WBA
ARCHITECTURE

30 August 2019

Pearl High School Multipurpose Building
WBA proj# 0419

ADDENDUM NO. 03

S2.1
CMU WALL PLAN

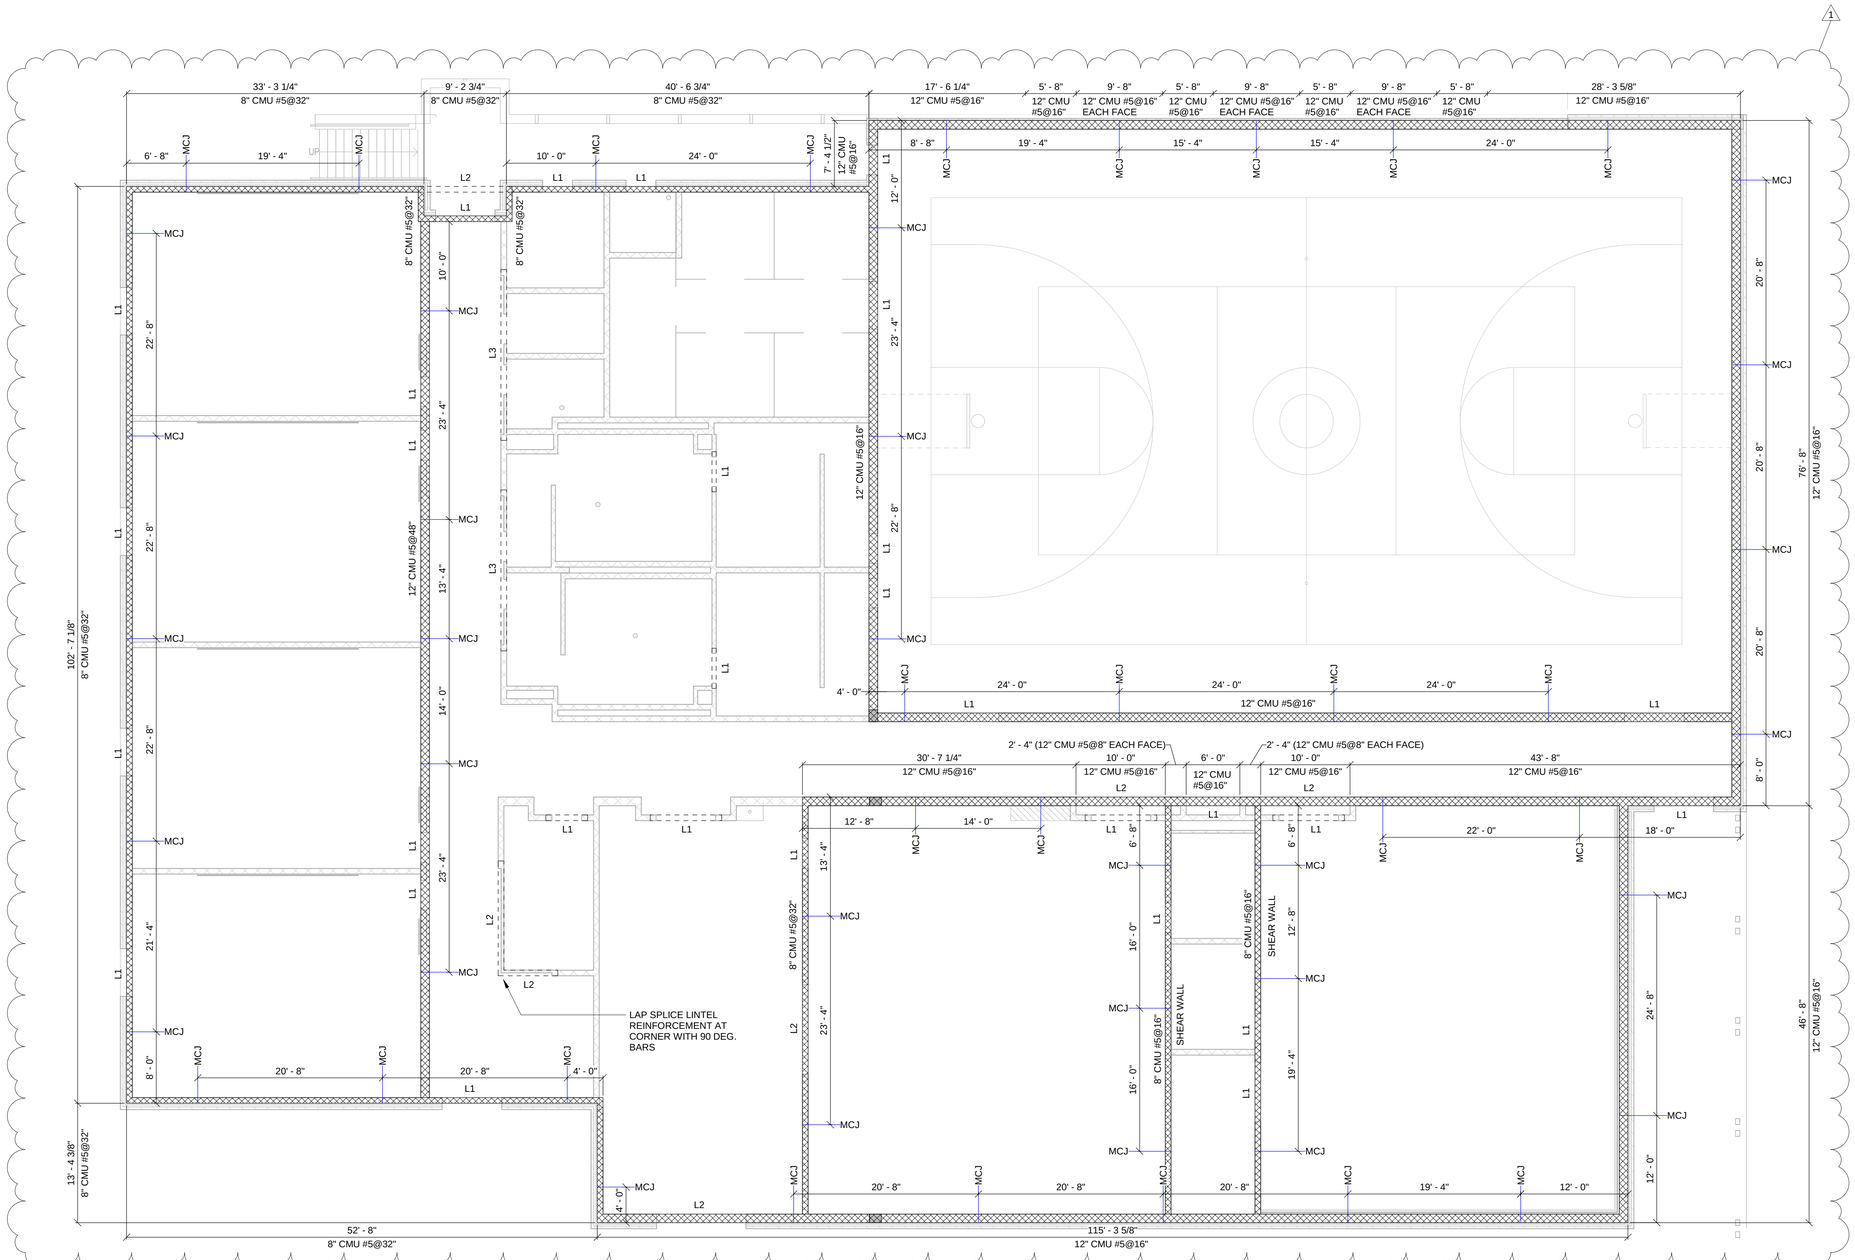
ITEM NO. 5 **S2.1 CMU WALL PLAN**
Revise per the **enclosed sheet.**
Added CMU wall vertical control joints.

MCJ = CONTROL JOINT IN CMU PER DETAIL 5 / S3.4
DIMENSIONS TO CONTROL JOINTS MAY BE ADJUSTED UP TO 8'. APPROXIMATE JOINT LOCATIONS WHERE DIMENSIONS ARE NOT PROVIDED. INSTALL VERTICAL CONTROL JOINTS AT A MAXIMUM SPACING OF 24' - 0" FOR INTERIOR CMU PARTITION WALLS.

S2.2
LOWER ROOF FRAMING PLAN

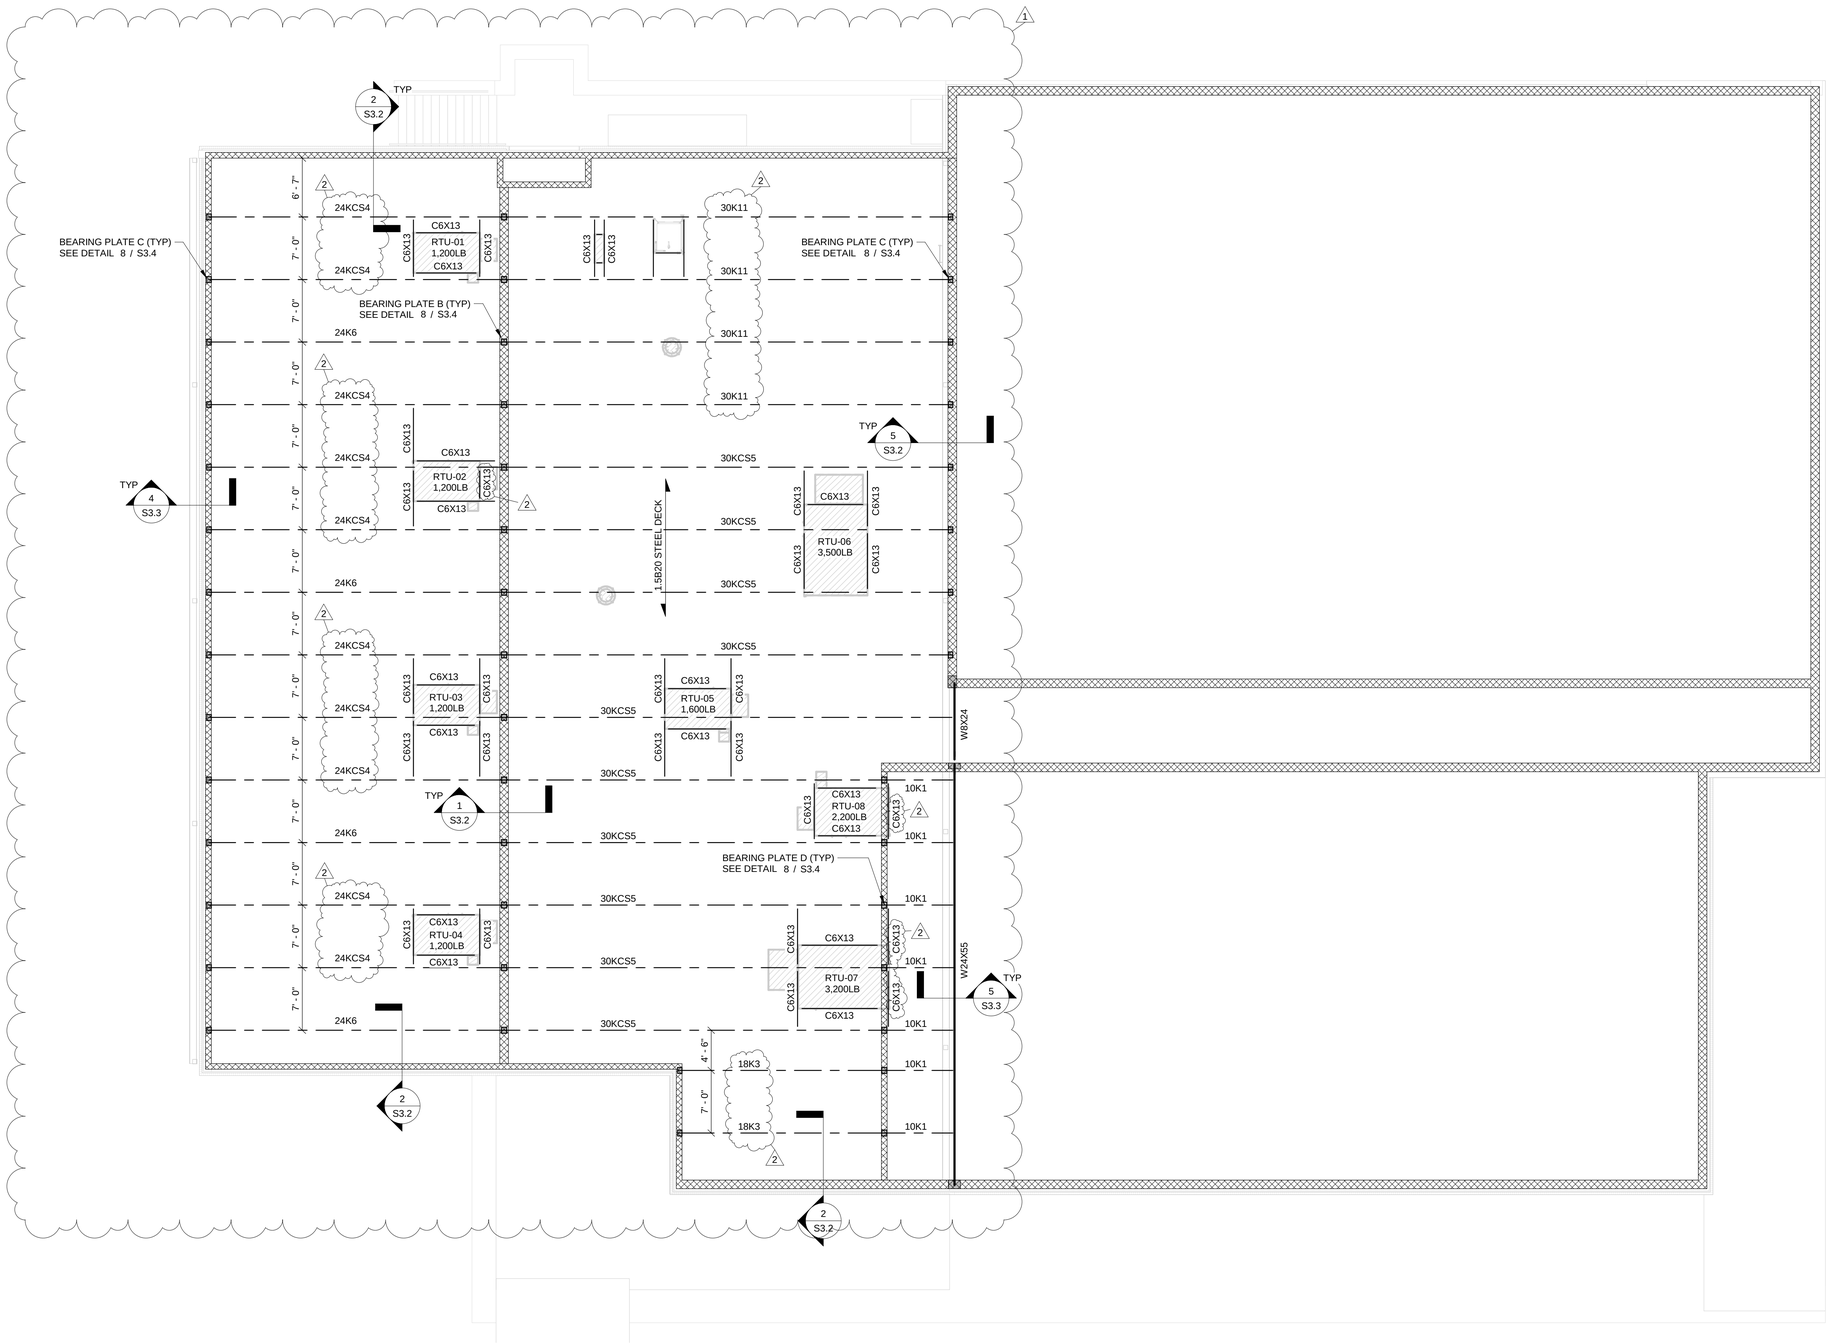
ITEM NO. 6 **S2.2 LOWER ROOF FRAMING PLAN**
Revise per the **enclosed sheet.**
Revised roof joist sizes and added steel channels for RTU support in four locations.

S2.3
UPPER ROOF FRAMING PLAN

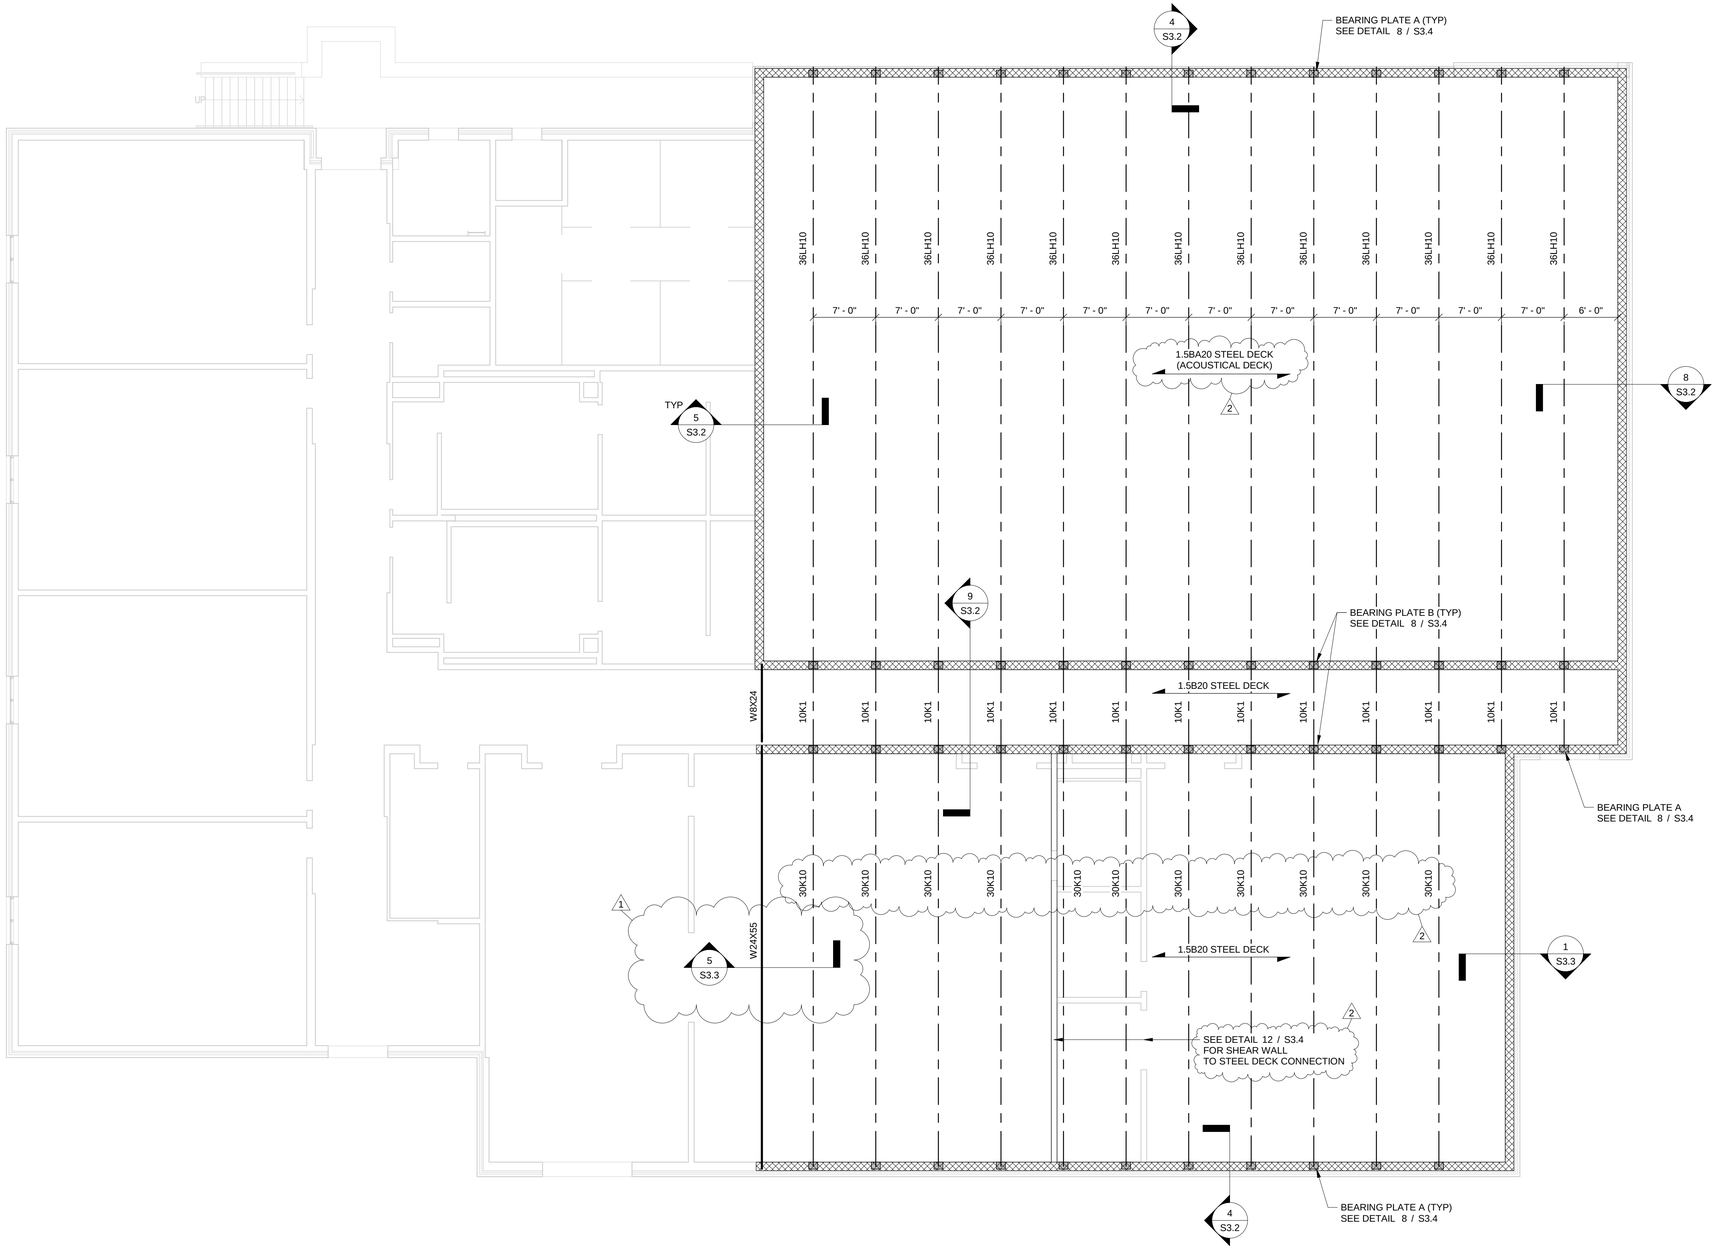
ITEM NO. 7 **S2.3 UPPER ROOF FRAMING PLAN**
Revise per the **enclosed sheet.**
Changed gym steel deck to acoustic steel deck and revised steel joist sizes above the drama and dance rooms.
